Subject 21 B. 21 Serai An,
28/1, SRS

herewith 2 copies of sketch plan showing R.C.C. floor for existing W.C. & bath, which you are requested to approve at an early date & oblige. The ^{work is of} wooden roof to be turned in to R.C.C. floor.

Case No. P.S. 680/34.

With reference to your application dated 20-11-34
with a plan for the proposed building/additions and alterations on plot
No. 21(23/1), Survey Sheet No. B-21(C.R.3) Serai Quarter
I have to request you to comply with the following requirements:—

SKETCH PLAN SHOWING R.C.C.
FLOOR ON BATH & W.C. ON PLOT
N.B. IN SHEET N^o 1 SERAI QRS.
SCALE 8" = 1'

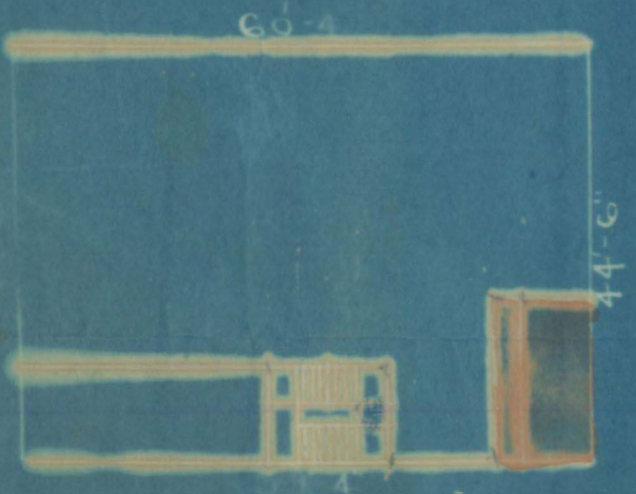
Separate soil pipe and waste water downtake pipe should be provided.

1. Side measurements must be corrected

2. Road widths must be shown

3. Position of Plot must be corrected

- ✓ 1. Separate soil pipe and waste water down take pipe should be provided.
- ✓ 2. Side measurements must be corrected.
- ✓ 3. Road widths must be shown
- ✓ 4. Position of plot must be corrected.

- (1) Separate soil pipe & waste water pipe have been provided on the site.
- (2) Side measurements have been corrected.
- (3) ~~4/4~~ complied with.
- (4) Position of the plot is correctly shown.

SKETCH PLAN SHOWING R.C.C.
FLOOR ON BATH & W.C. ON PLOT
(old) N. 21 N. SHEET N. 21 SERAI QRS.
SCALE 8'-1"

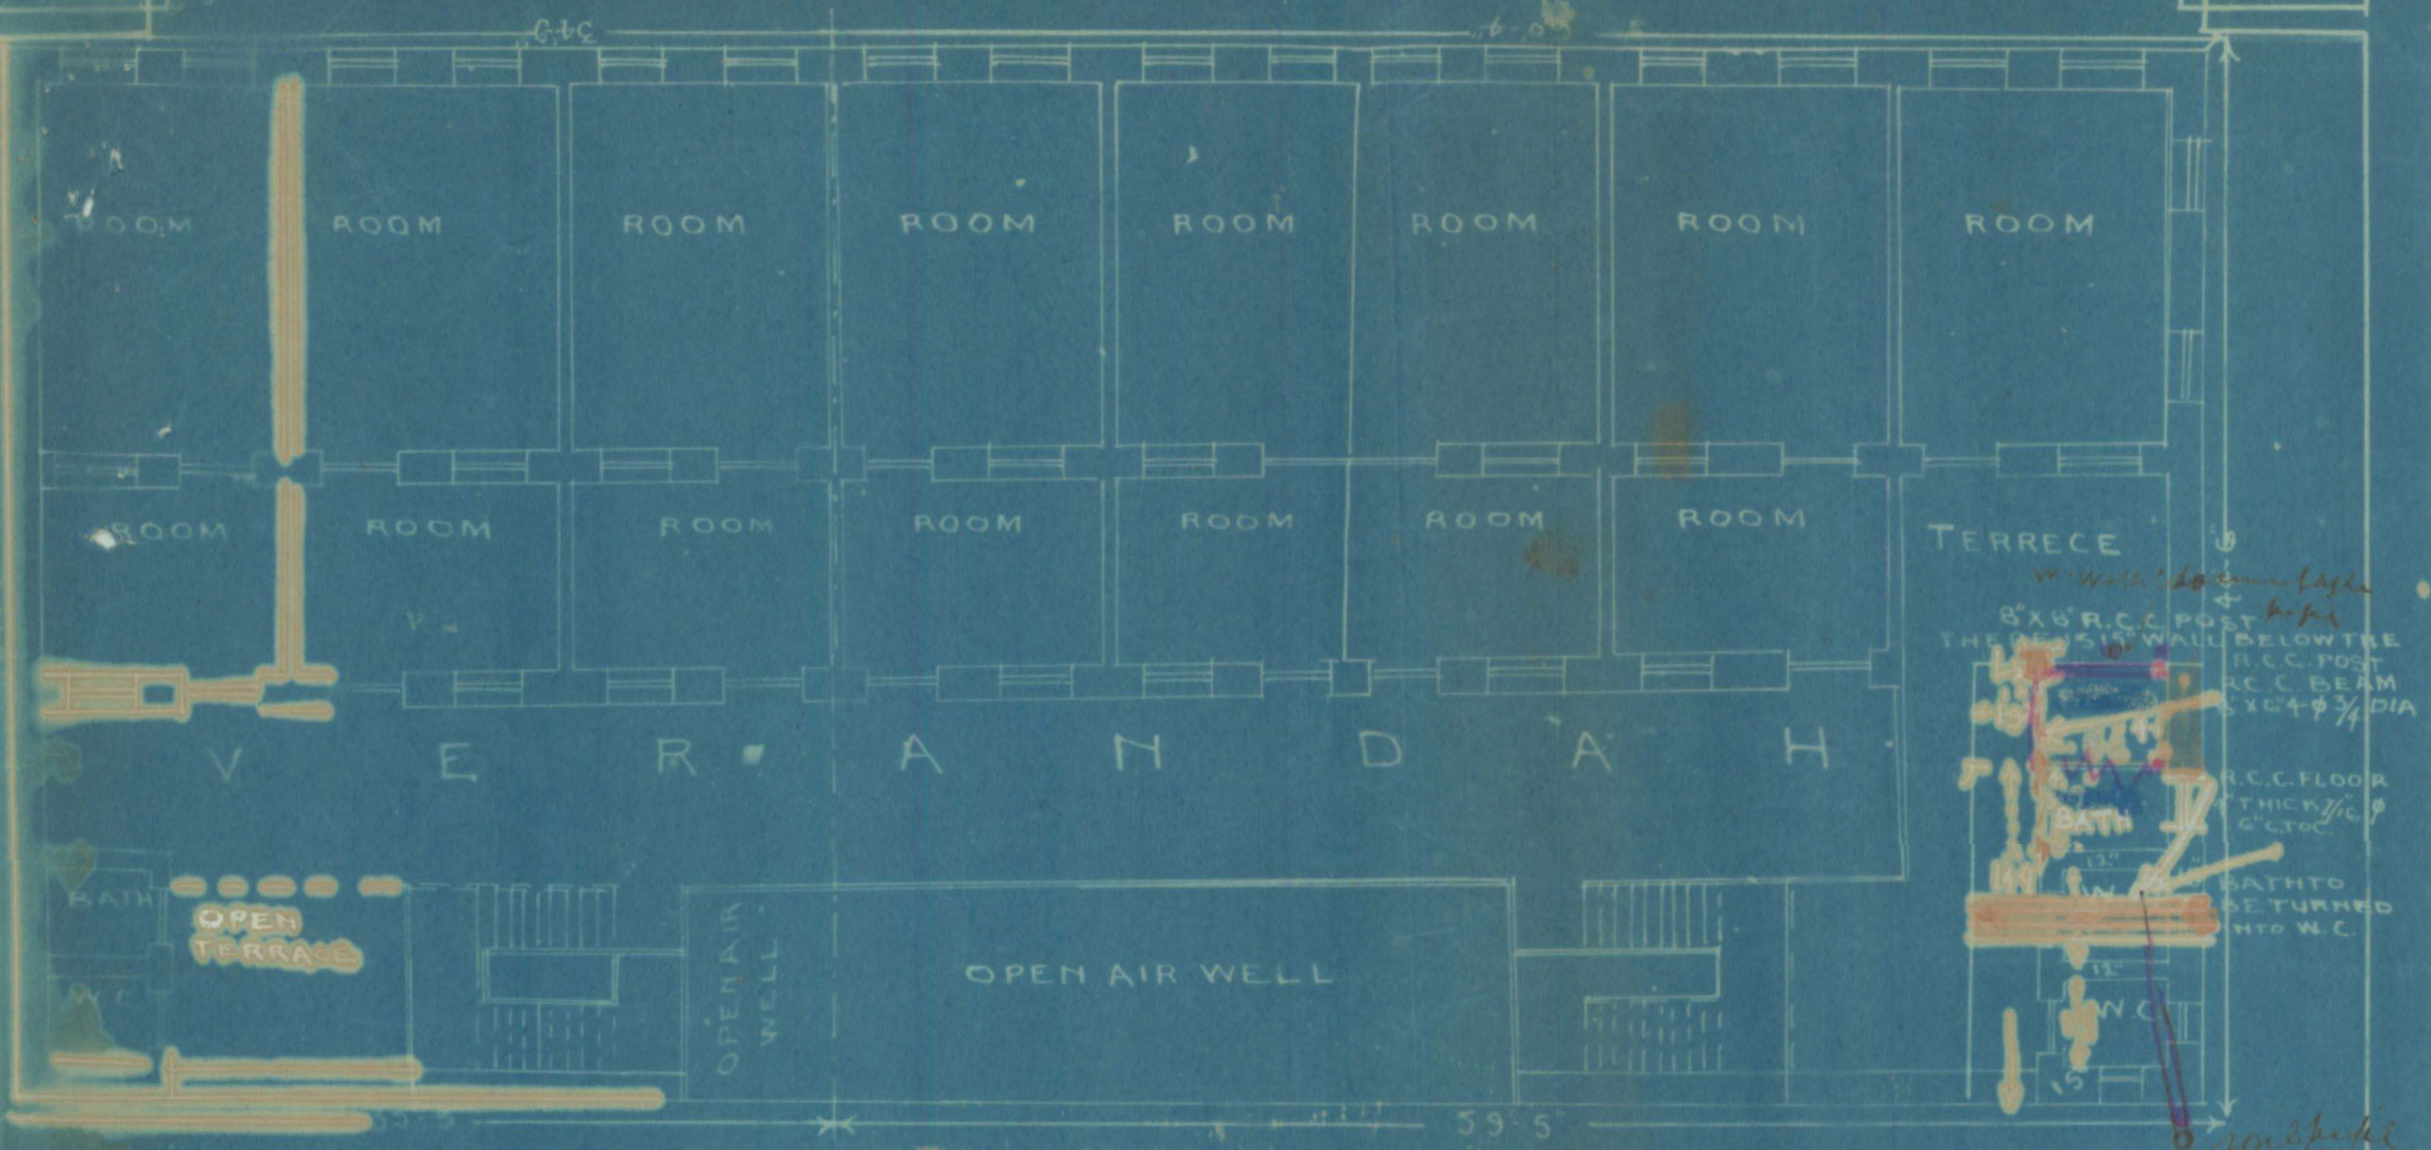
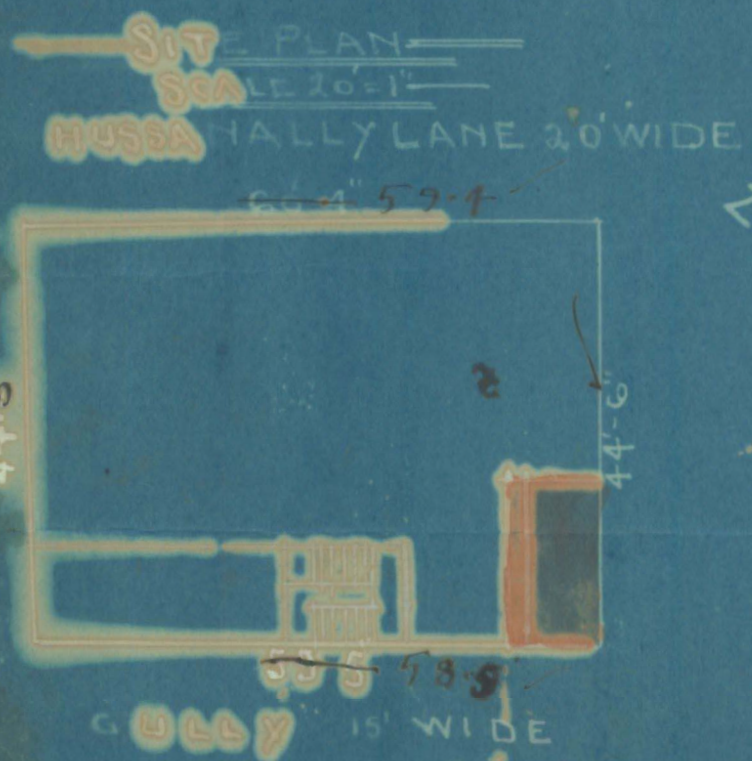
no objection
supplied by
to architect
not complied
RMP

no objection
H.P. 4/24/35
